1210F SPL 170XL Interaxle Driveline

1210F / NHTSA Recall ID: 10V634000 / Transport Canada ID: 2010-441

SPL 170XL Interaxle Driveline

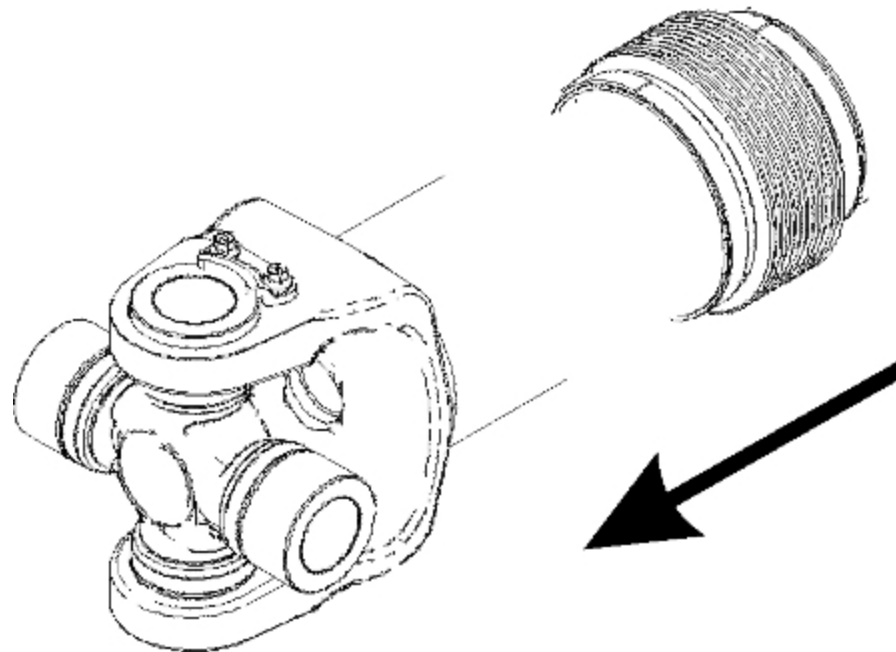
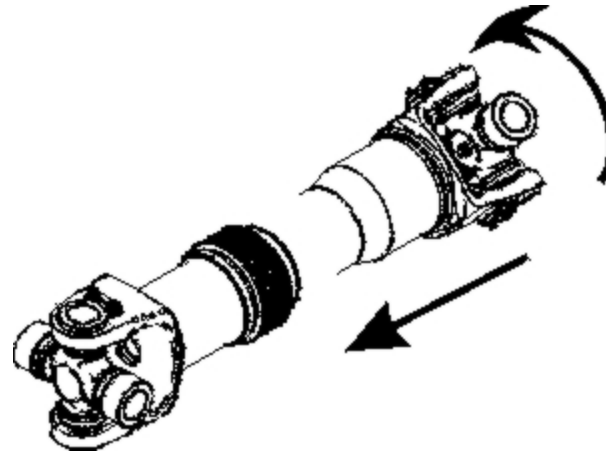
5. Phase the driveline by rotating it four (4) spline teeth in a CLOCKWISE direction (from the back of the truck facing the front of the truck), based

on the phasing marks you made in Step 1. Reassemble the two driveline sections, using a new u-joint assembly, a new boot and new boot clamps. Tighten the boot clamps using Oeitikar pliers.
